⚠ ADDENDUM No. 1

MD 108 AND

AUTO DRIVE /SIGNAL BELL LANE

TRAFFIC SIGNAL PLAN

DRAWING NO. TS--3409B

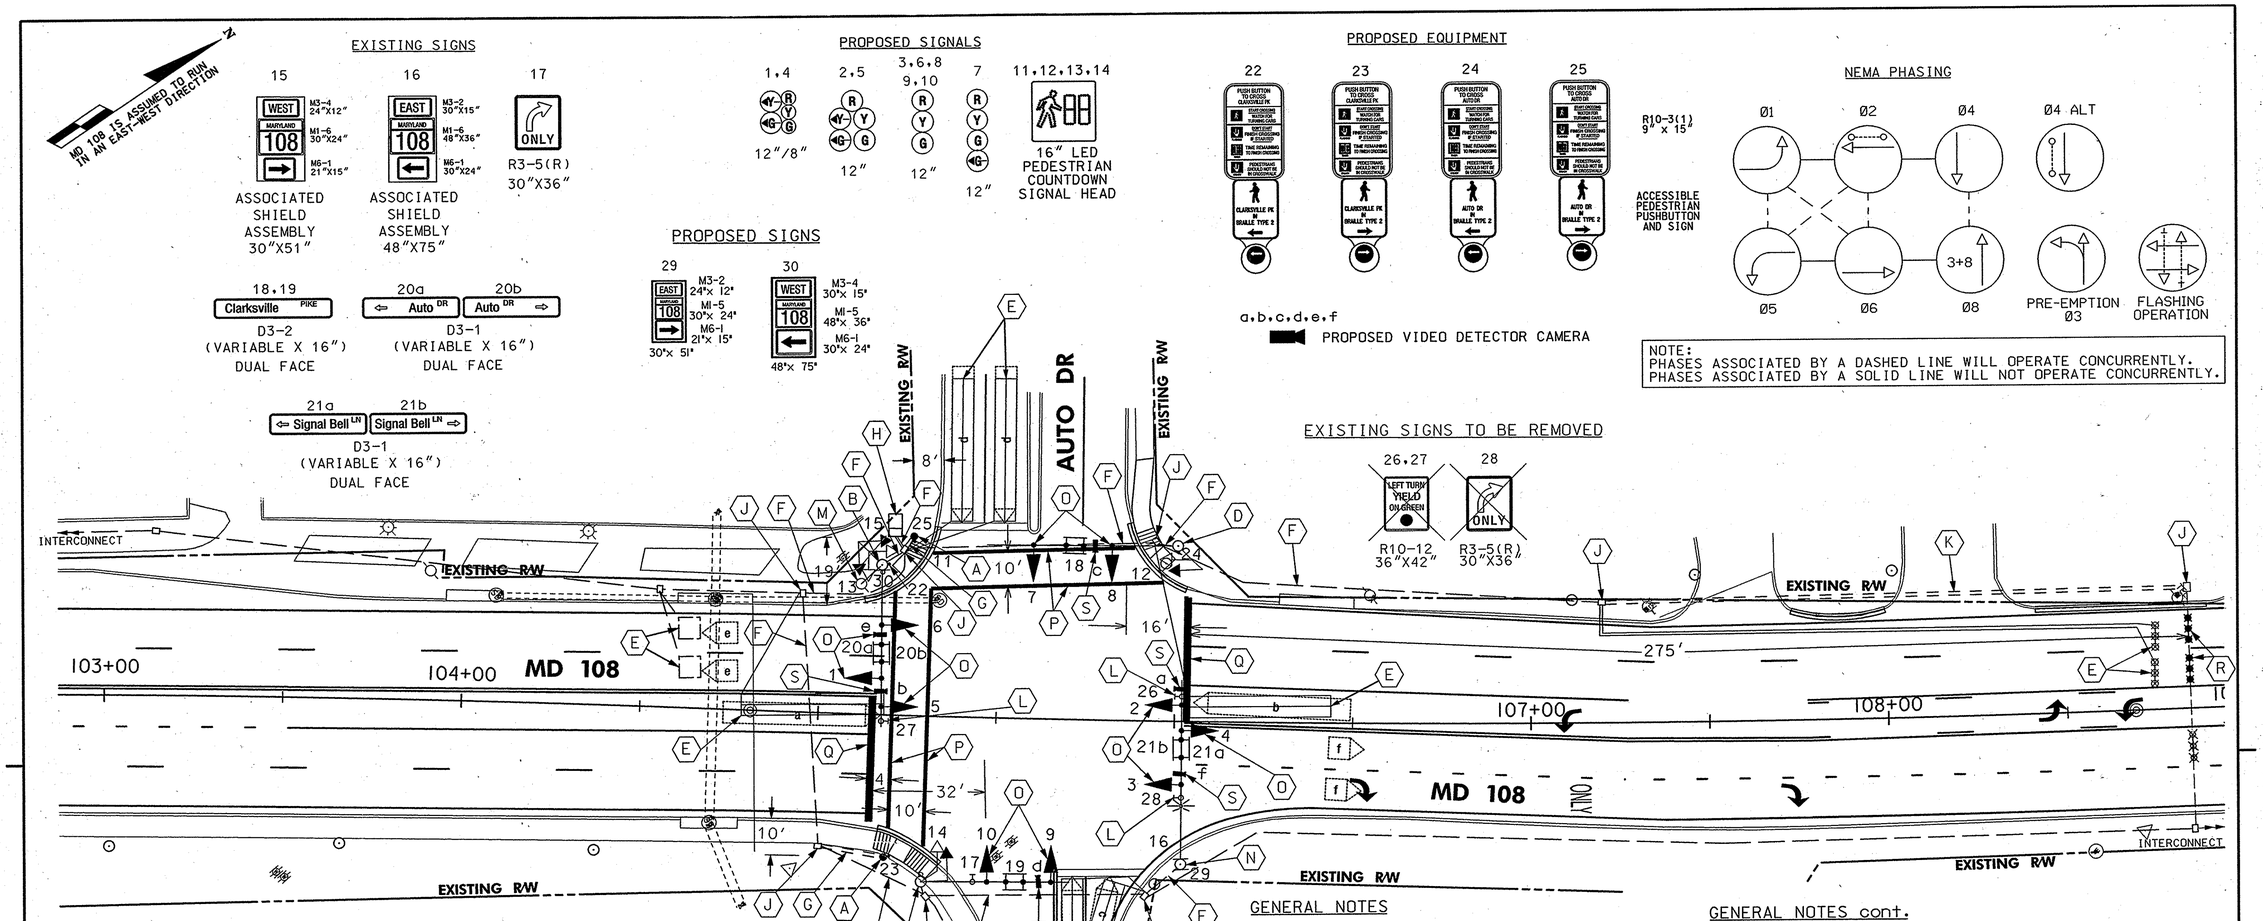
B	UPGRADE TO LED SIGNAL HEADS, APS, AND COUNTDOWN PED SIGNALS.INSTALL VIDEO DETECTION AND NON-INVASIVE MICROLOOP PROBES. SHA NO.: H0358017				3/19/07
S/W	A.M. SPY	W.E.			P.E. C.H.
A	11-22-06 MODIFY SIGNAL DUE TO NEW GEO'S ON THE SOUTHSIDE OF MD 108 SHA NO.:				
RRZ	MAR	OUB		BRK	TH 12/4
